Datum
24. Juli 2018

Ref: Urgent Safety Information THERA-Trainer balo / THERA-Trainer verto

Movement therapy device – THERA-Trainer balo, THERA-Trainer verto

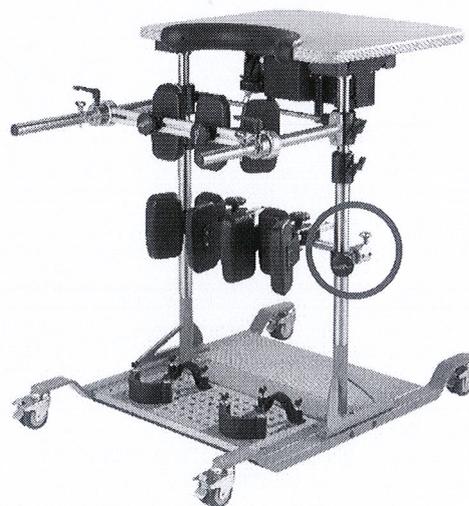
The hexagon socket set screw of the mounting mechanism of the knee support is broken.

As a cause, we detected a hydrogen embrittlement of the galvanized hexagon socket set screw with the strength ≥ 10.9 . This hydrogen embrittlement can occur irregularly. The damage can happen during low load already. If the hexagon socket set screw breaks, the knee support can fall off on one side and the patient will become instable during lifting process or during therapy.

- Please stop exercising with THERA-Trainer balo / THERA-Trainer verto until a modification was done.
- We, medica Medizintechnik GmbH, will send you within the next 4-5 weeks spare parts incl. service manual in order to exchange the relevant components. Please exchange the components and return the completed answer form to us.
